CITY PLAN COMMISSION**THURSDAY, MAY 8, 2025****FILE NUMBER:** S245-148**SENIOR PLANNER:** Hema Sharma**LOCATION:** Crouch Road at Lancaster Road/State Highway No. 342, southwest corner**DATE FILED:** April 10, 2025**ZONING:** PD 625**PD LINK:** <https://dallascityhall.com/departments/city-attorney/Articles/PDF/Article%20625.pdf>**CITY COUNCIL DISTRICT:** 8**SIZE OF REQUEST:** 15.804-acres**APPLICANT/OWNER:** City of Dallas, Tomfirm Camp Wisdom LP

REQUEST: An application to create a 202-lot single family subdivision with lots ranging in size from 1,360 square feet to 3,400 square feet, one amenity lot, 9 common areas and to dedicate a right-of-way from 15.804-acre tract of land in City Block 6896 on property located on Crouch Road at Lancaster Road/State Highway No. 342, southwest corner.

STAFF RECOMMENDATION: The request complies with the requirements of the PD 625; therefore, staff recommends approval of the request subject to compliance with the following conditions:

RESIDENTIAL ADDITION		CITY BLOCK 8896	
CITY BLOCK A/261		LOUIS HENST SUPER, ASBESTAC NO. 556	
DALLAS COUNTY, TEXAS		CITY PLAN FILE NUMBER 5245-148	
ENGINEERING PLAN NUMBER OF _____		SHEET 1 OF 3

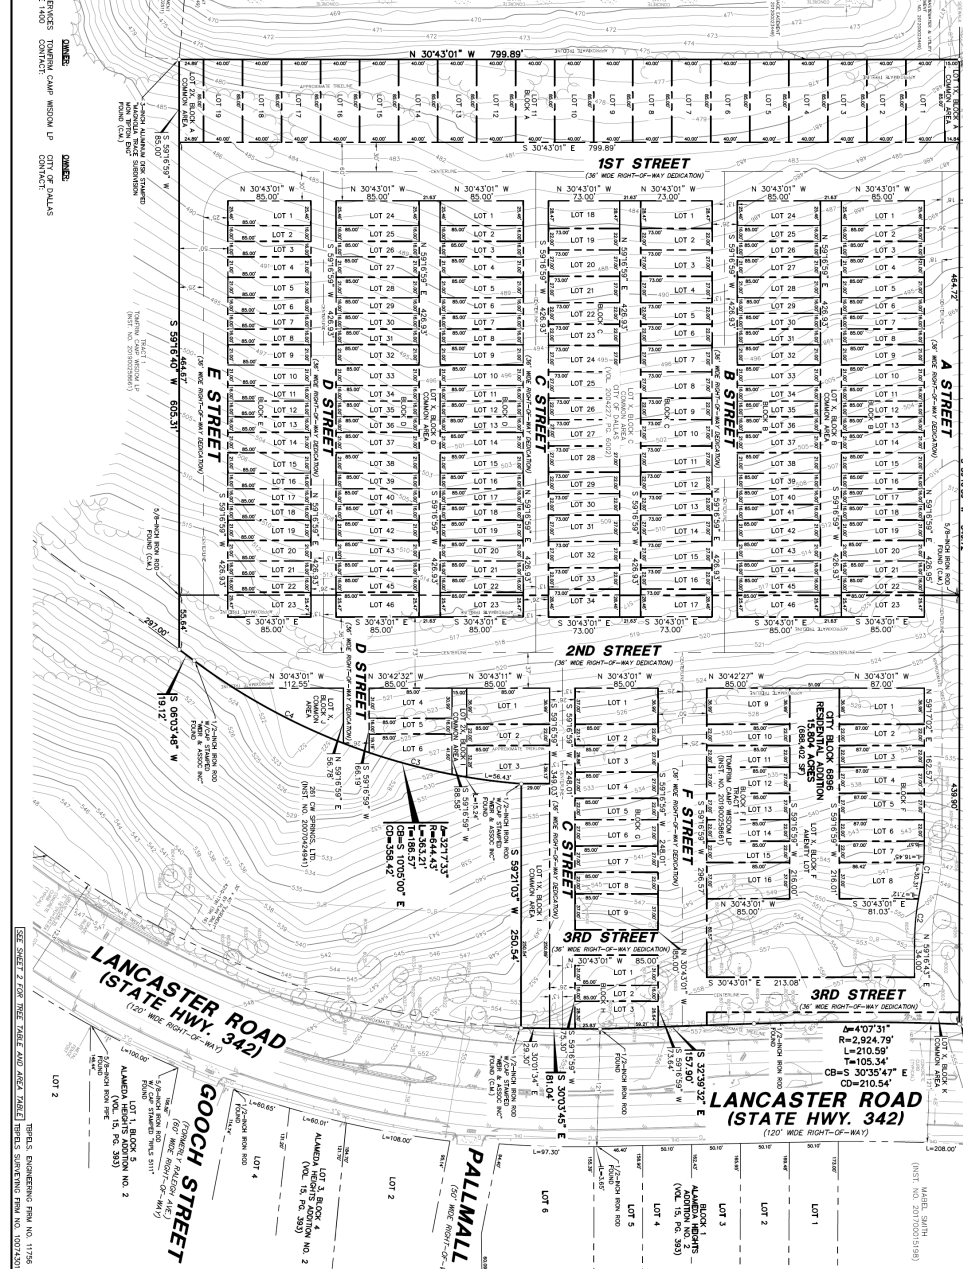
15. On the final plat, dedicate 53.5 feet of right-of-way (via fee simple) from the established center line of Lancaster Road. *Section 51A 8.602(c)*
16. On the final plat, dedicate 30 feet of right-of-way (via fee simple) from the established center line of Crouch Road. *Section 51A 8.602(c)*

17. On the final plat, dedicate a minimum 20-foot by 20-foot corner clip (via fee simple or street easement) at the intersection of Lancaster Road & Crouch Road. Section 51A 8.602(d)(1)
18. A larger corner clip may be requested during engineering plan and traffic review to accommodate an adequate turning radius, or to maintain public/traffic appurtenances, within the area of the corner clip. *Section 51A 8.602(d)(1), 51A 8.608(a)*
19. On the final plat, add the note: "TxDOT approval may be required for any driveway modification or new access point(s)."
20. Must coordinate with Transportation Department for any traffic signal requirements that are deemed necessary for improving pedestrian accessibility and safety related to site development (Contact Srinivasa Veeramallu with Traffic Signals). *51A-8.606, 51A-8.608*

32. On the final plat, change "Lancaster Road (State Hwy. 342)" to "Lancaster Road/State Highway No. 342". section 51a-8.403(a)(1)(a)(xii).
33. On the final plat, change "Pallmall Ave." to "Pall Mall Avenue". section 51a-8.403(a)(1)(a)(xii).

34. On the final plat, change "Gooch Street (Formerly Raleigh Ave)" To "Gooch Street (FKA Raleigh Street)". section 51a-8.403(a)(1)(a)(xii).
35. Contact Addressing Team for appropriate names for proposed ROWs: A to F Street.

36. Contact Addressing Team for appropriate name for proposed ROW - "1ST Street" already exists.
37. Contact Addressing Team for appropriate name for proposed ROW - "2ND" already exists.

38. Contact Addressing Team for appropriate name for proposed ROW - "3RD" already exists
39. On the final plat, identify the property as Block D/6896 through Block H/6896 and Block J/6896 through Block N/6896.
